Planning Commission - Regular Meeting City and Borough of Juneau

November 27, 2018
Assembly Chambers
7:00 PM

A. SMF2018 0001: Subdivision of one (1) lot into five (5) lots within a PUD

A SUBDIVISION PLAT OF
SUNSET HEIGHTS
PLANNED COMMUNITY
A SUBDIVISION OF LOT 7B1
WITHIN U.S. SURVEY NO. 2960
CITY & BOROUGH OF JUNEAU, ALASKA
JUNEAU RECORDING DISTRICT

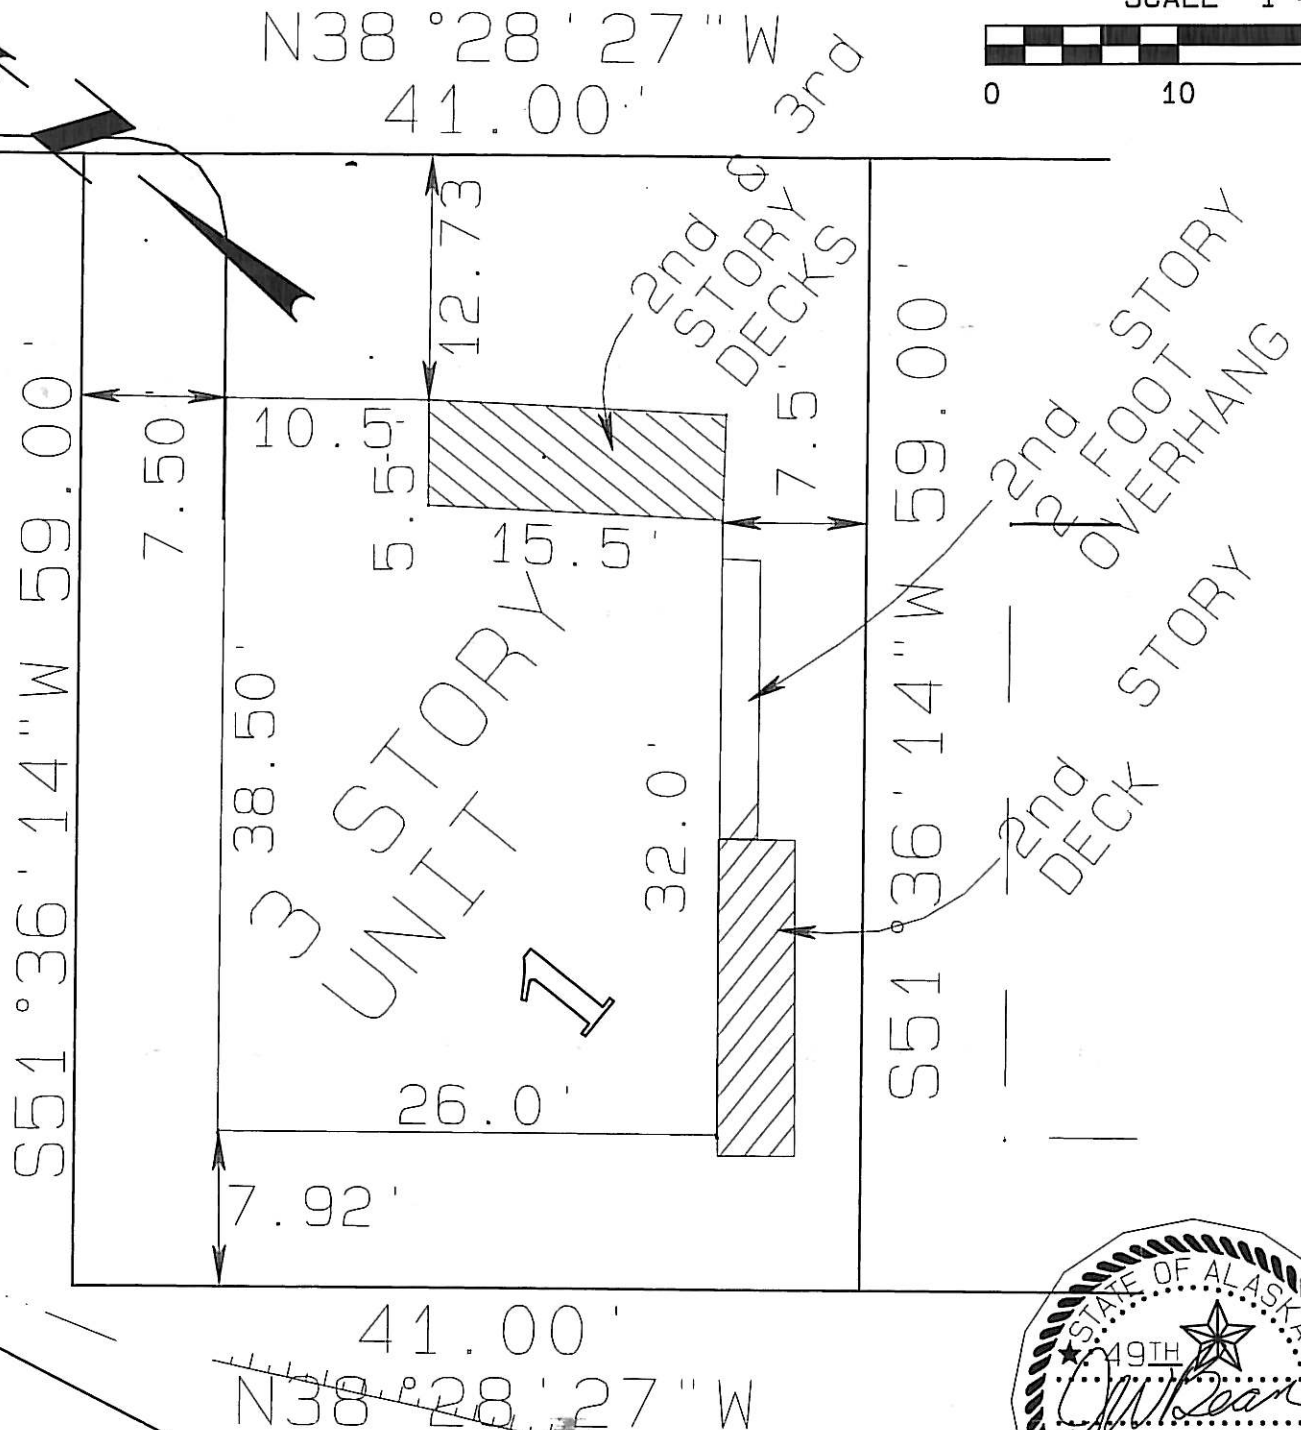
2. Title Block
 - a. Revise title block (you could also shorten the name to just “SUNSET HEIGHTS”):

3. Plat Graphic
 - a. Show the private drive and label it “TEUFELSHUND WAY”
 - b. Change the name of LOT 7B1 to “LOT 13”, and use a dashed or ghost font to label previous LOT 7B1.
 - c. Prior to final plat recording, remove all structures from the plat.
 - d. Prior to final plat recording, remove phases two and three from the plat, only showing lots 1-4 and lot 13.

- e. Prior to final plat recording, remove the note "DEVELOPMENT RIGHTS RESERVED IN PHASE 2&3 MAY BE WITHDRAWN. UNITS SHOWN HEREON ARE PROPOSED AND NEED NOT BE BUILT."
- f. Remove the "Typical Foundation with Setbacks" graphic within the plat graphic.

Comments: The developer requested not to change the name of the subdivision. Formatting of the Title Block has been met as required.

NEW FIGURE 3

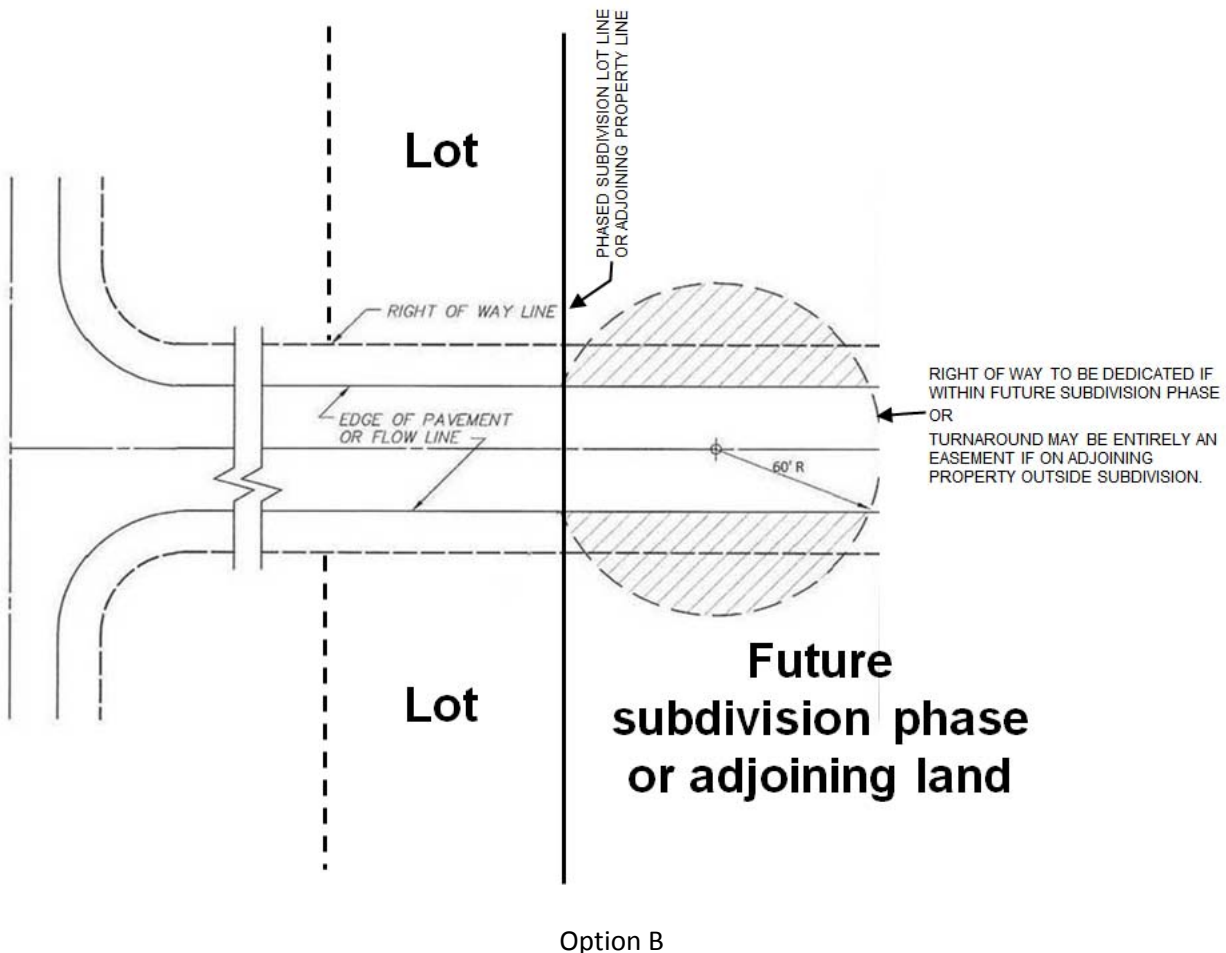
The maximum length of unconstructed roadway between the temporary turnaround and the adjoining property shall be the minimum lot width for the zoning district in which the right-of-way is located. Where a right-of-way is situated in more than one zoning district the shortest minimum lot width for those zoning districts shall be used. See Figure 3 – Option A.

Deleted OLD SHOWN
ABOVE

- (G) The temporary turnaround may be located on property within the subdivision intended for future subdivision phases in conjunction with a platted right-of-way. It may also be located outside the subdivision boundary entirely within an easement. See Figure 3 – Option B. For temporary turnarounds located in this way curb, gutter, and sidewalks are not required for the temporary turnaround.

Figure 4

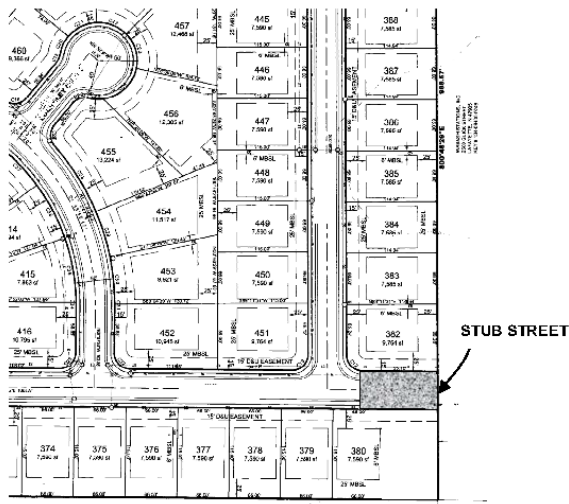
- (E) No additional lots are being platted.
 - (2) *Stub streets.*
 - (A) The director for minor subdivisions and the commission for major subdivisions may waive the full construction of a roadway within a right-of-way that is required to provide access to a bordering property, and does not provide required access to any lot within the subdivision. It shall be demonstrated that the unconstructed roadway can be constructed to CBJ standards. The commission or director may require provision of a roadbed, utility line extensions, or other appropriate improvements (See Figure 4).
